## DEPARTMENT OF ENVIRONMENTAL QUALITY DIVISION OF RADIATION CONTROL

Re: State Update Report for Intensive Ammonia Sampling of Colorado River and Request for Additional Studies: Atlas Uranium Tailings Near Moab, Utah.

SUBJECT: Atlas Tailings: Results of September, 1996 Intensive Ammonia Sampling of Colorado River.

**FIGURE 1**

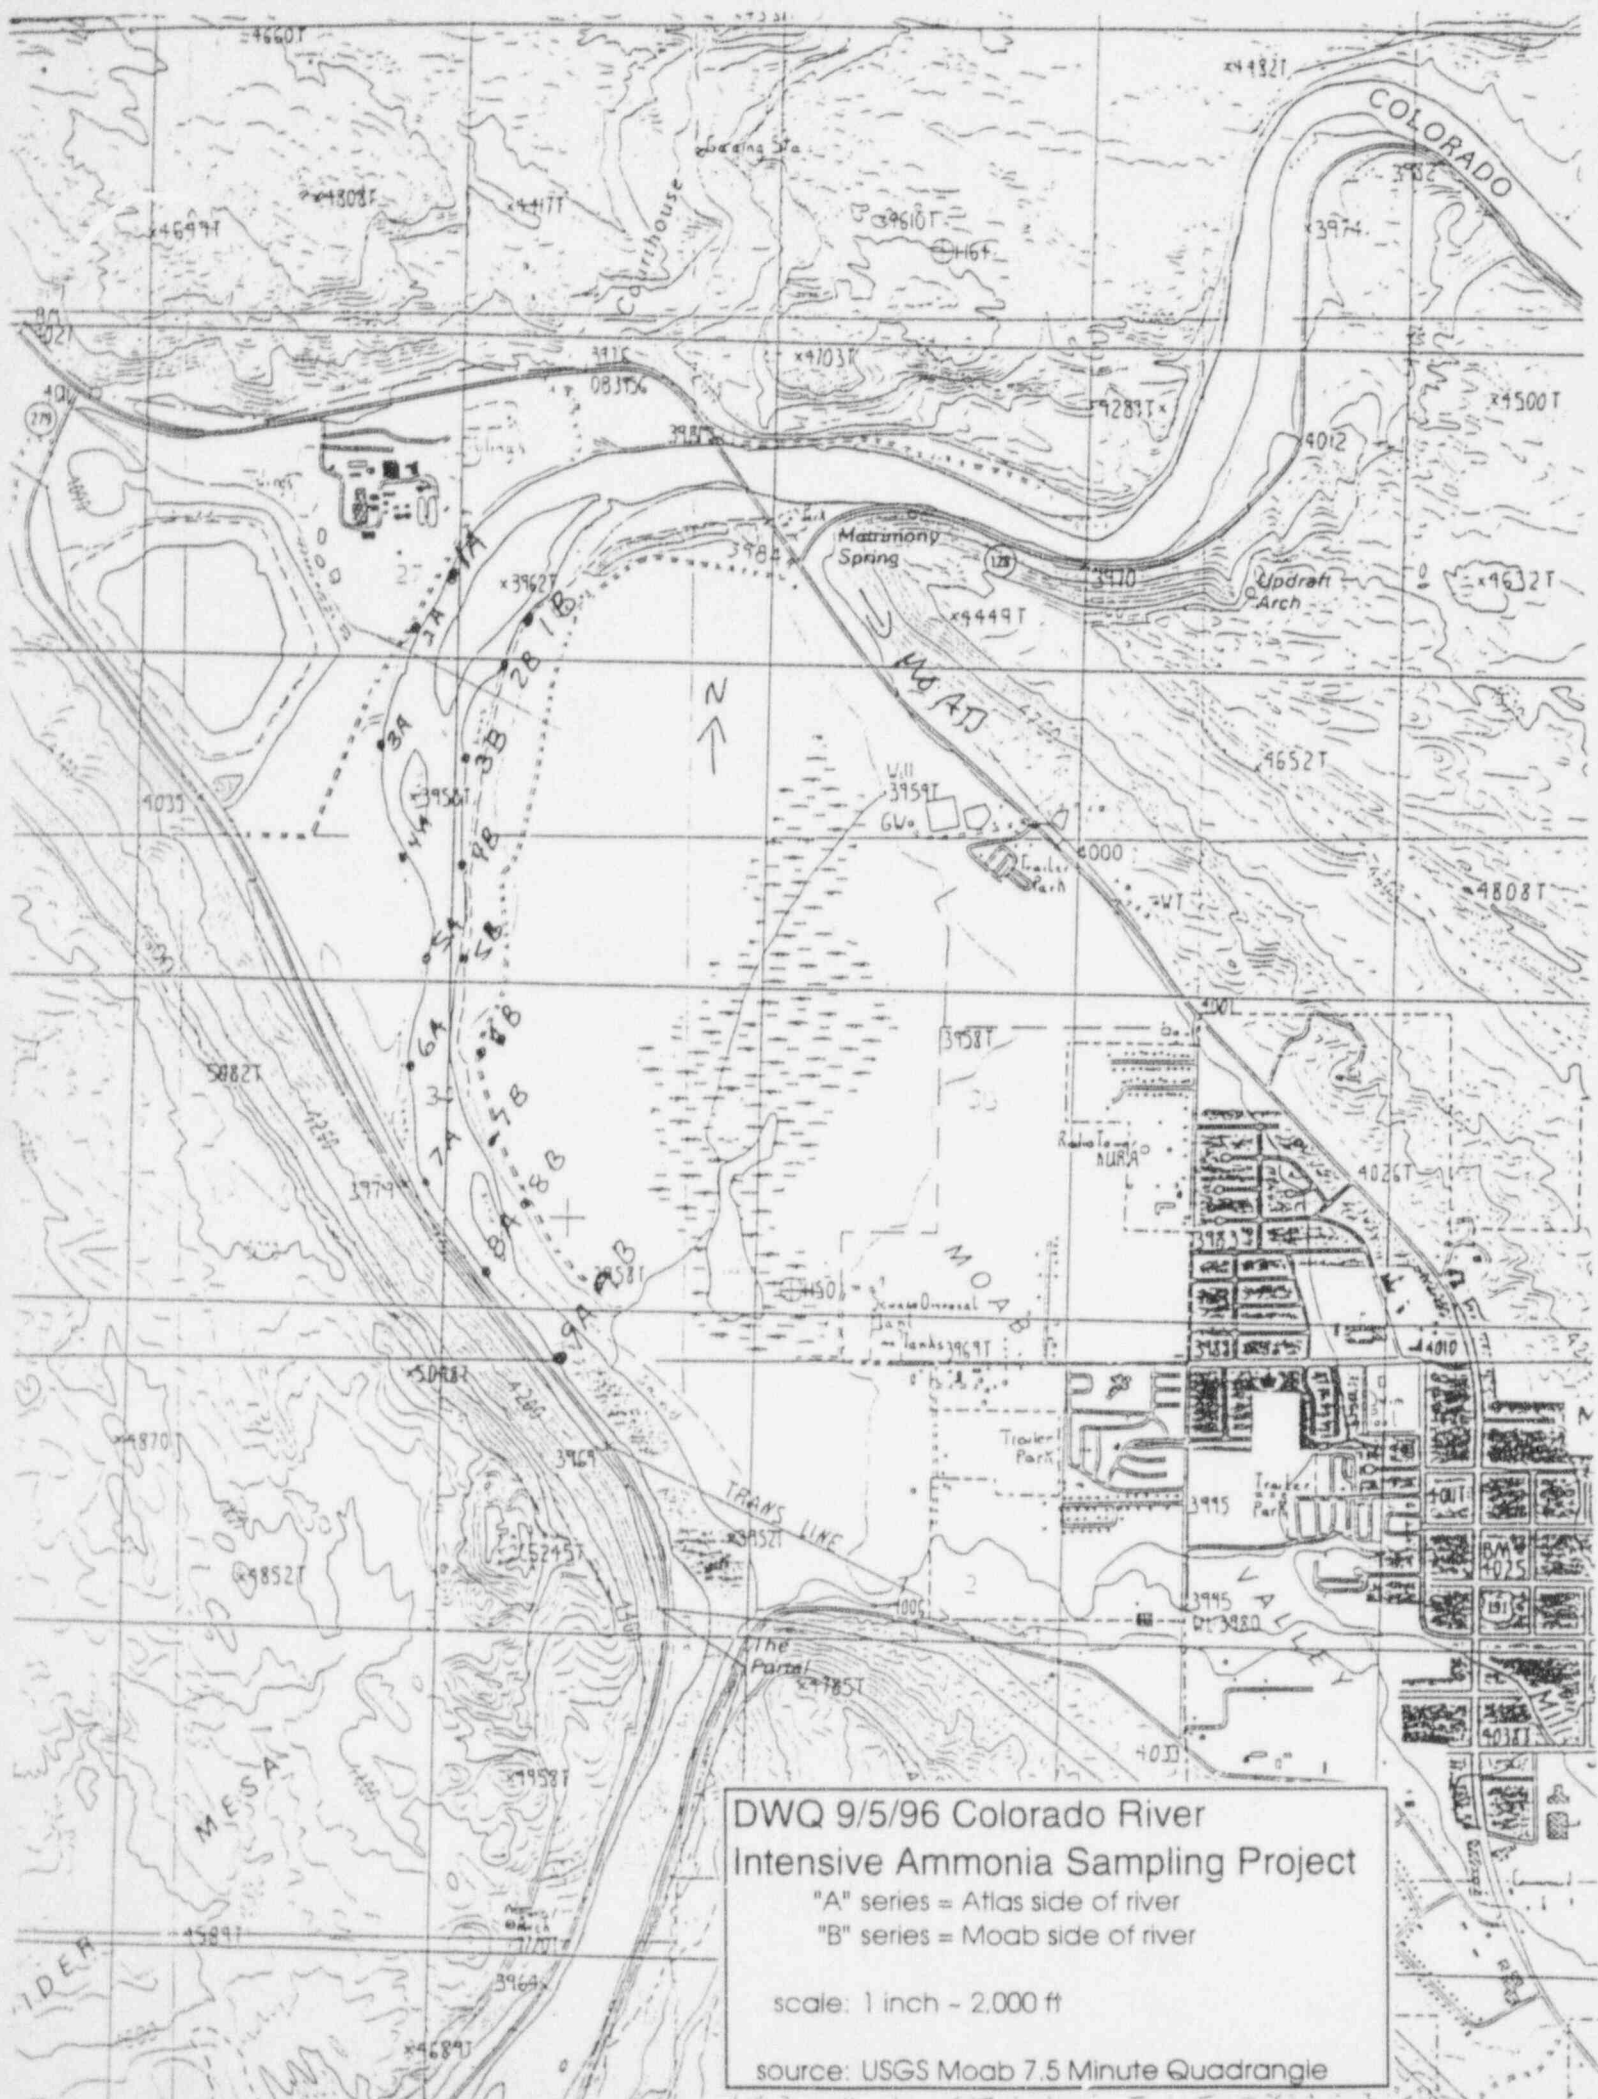
During the September 5, 1996 sampling event, DWQ staff collected 18 separate samples of ammonia (N) from the river in the vicinity of the Atlas tailings pile. Half of these samples were collected from the Atlas side of the river, or north and west riverbank (see Figure 1, samples A1 thru A9). The remaining nine samples were collected from the Moab side of the river, i.e., south and east riverbank at locations that were approximately directly across from the "A" series samples (see Figure 1, samples B1 thru B9). All the samples collected were grab-type measurements taken within a short distance of the riverbank. As has been done with all previous DWQ sampling, sample collection and preservation was completed in accordance with the DWQ water quality monitoring quality assurance plan. All analysis was completed by the Utah State Health Laboratory; an EPA certified environmental laboratory.

## **ATTACHMENT 1**

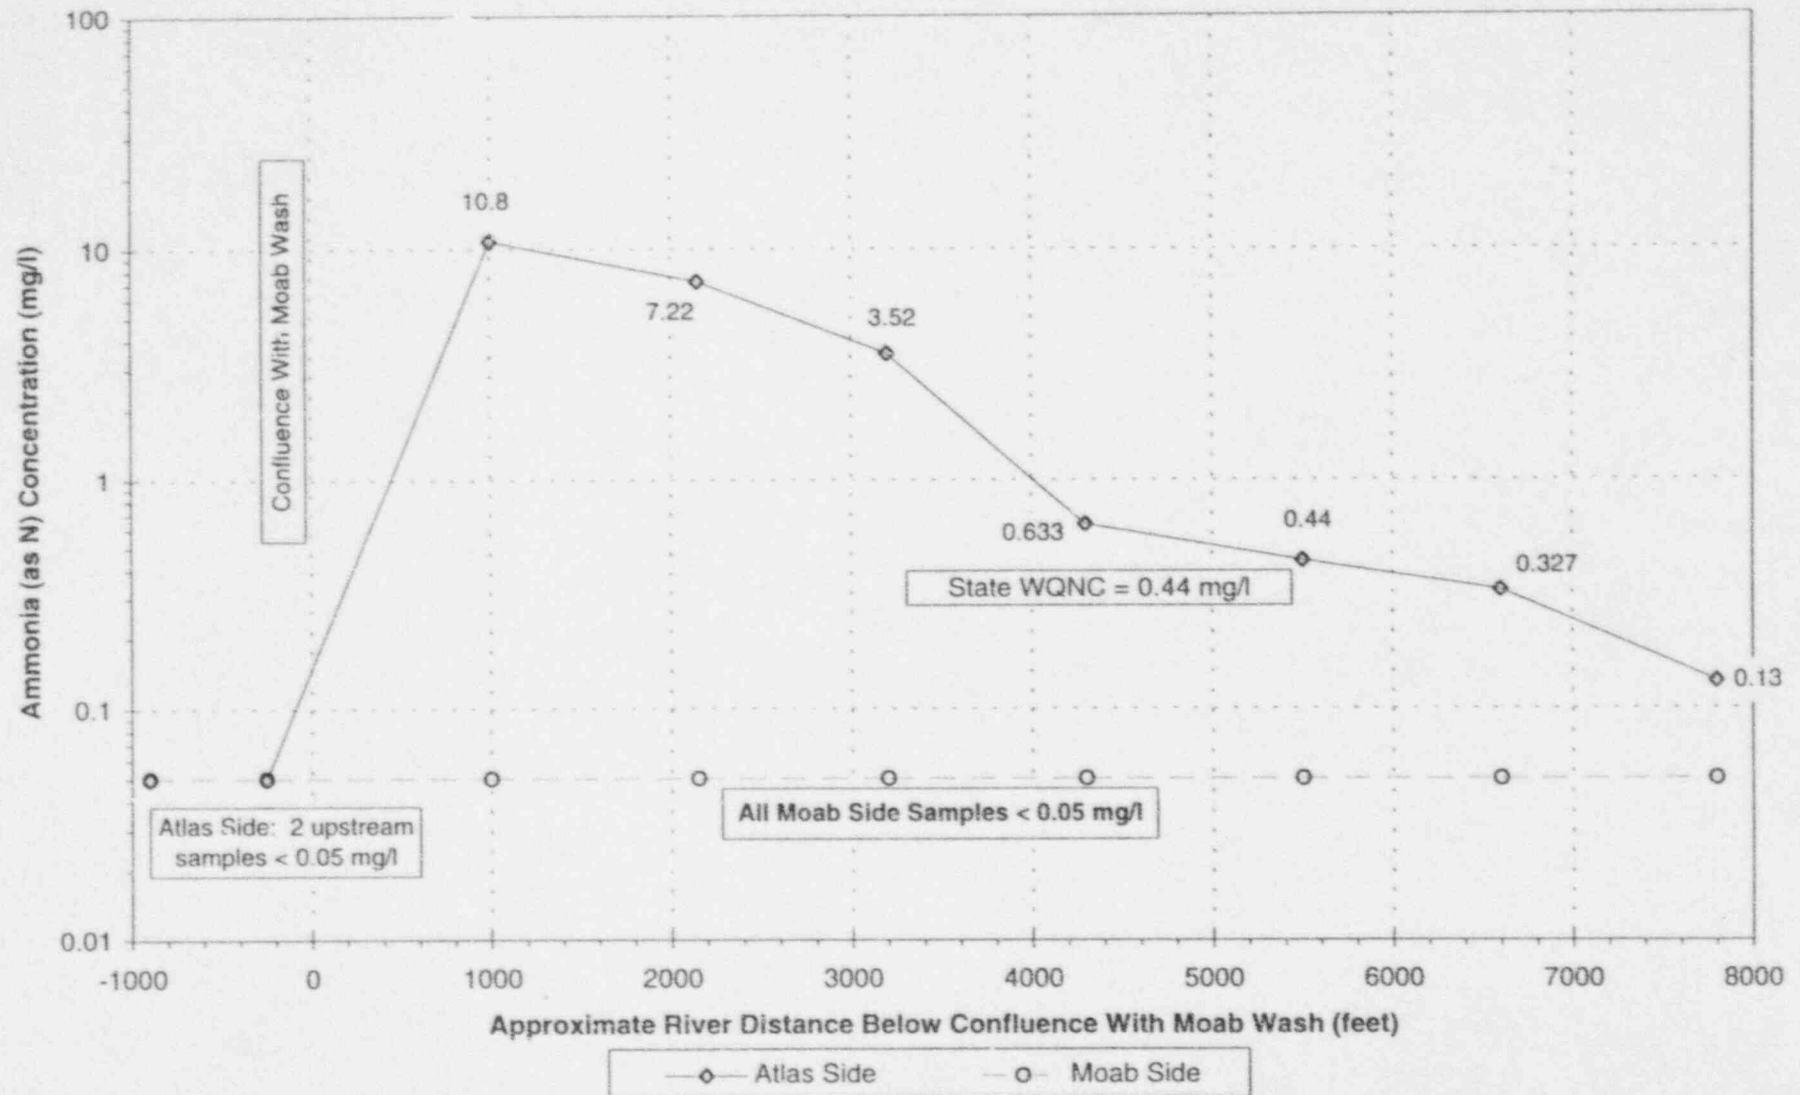
1. Significantly Higher Ammonia Concentrations on Atlas Side - available data shows that the highest ammonia (N) was found on the Atlas side of the river, where an average concentration of about 2.57 mg/l was measured (see Attachment 1, DRC spreadsheet NH3\_9-96). In contrast, all samples collected from the Moab side were found below minimum detectable concentration levels (< 0.05 mg/l).

Both the average (2.57 mg/l) and maximum (10.8 mg/l) ammonia concentrations seen on the Atlas side of the river exceed the State surface water quality standard (0.44 mg/l, Water Quality Numeric Criteria, or WQNC). As a result, the potential exists for local adverse impact to the Colorado River water quality. Consequently, Atlas should be required to complete additional water quality studies to determine local extent and long-term effects of the discharge of tailings contaminants to the river.

2. Background River Concentration and Concentration Trend (Atlas Side) - background concentrations on the Atlas side of the Colorado River appear to have been found at upstream stations A1 and A2 where ammonia (N) content was found below 0.05 mg/l (see Attachment 1, DRC spreadsheet and graph). However, downstream of station A2 a dramatic increase in ammonia content was observed. Somewhere between stations A2 and A3 ammonia (N) concentrations rose from below detectable levels (< 0.05 mg/l) to 10.8 mg/l; an increase of more than two orders of magnitude across a distance of only about 1,250 feet.

Downstream of station A3 a consistent decreasing trend was apparent with ammonia concentrations falling from 10.8 mg/l to 0.13 mg/l between stations A3 and A9 (ibid.). This dramatic ammonia increase near station A3 followed by gradual declines downstream to station A9 suggest the Atlas tailings pile is a local point source of ammonia discharge to the Colorado River.

4. Downstream Extent of Elevated Ammonia Concentrations (Atlas Side) - review of the September 5, 1996 data suggests that the ammonia (N) concentrations are elevated above background values for a distance of more than 7,800 feet below the river's confluence with Moab Wash (see Attachment 1).
5. Apparent Downstream Extent of Mixing Zone (Atlas Side) - review of the September 5, 1996 data shows that the State WQNC (0.44 mg/l) was exceeded on the Atlas side of the riverbank for a distance of about 4,500 feet between stations A3 to A7 (see Attachment 1). Depending on the exact location of the upstream ammonia discharge to the river between stations A2 and A3, and the point at which the WQNC is regained between stations A7 and A8, it is possible that in-stream WQNC for ammonia could have been exceeded for a mile or more along the Atlas side of the river.

From the information available it is clear that Atlas should be required to complete additional river sampling to better define and characterize the zone of contaminant impact in the river and the full extent of the mixing zone needed to regain State water quality standards (WQNC). Such additional study should include samples collected at both low flow conditions and through other seasons of the year to determine both average and worse case conditions. Because mixing zone length is contaminant specific, these additional studies should be expanded to include other key tailings contaminants. In order to gain a comprehensive understanding of impact of the tailings contaminants on the river, sediment quality and biotic studies may also need to be included.
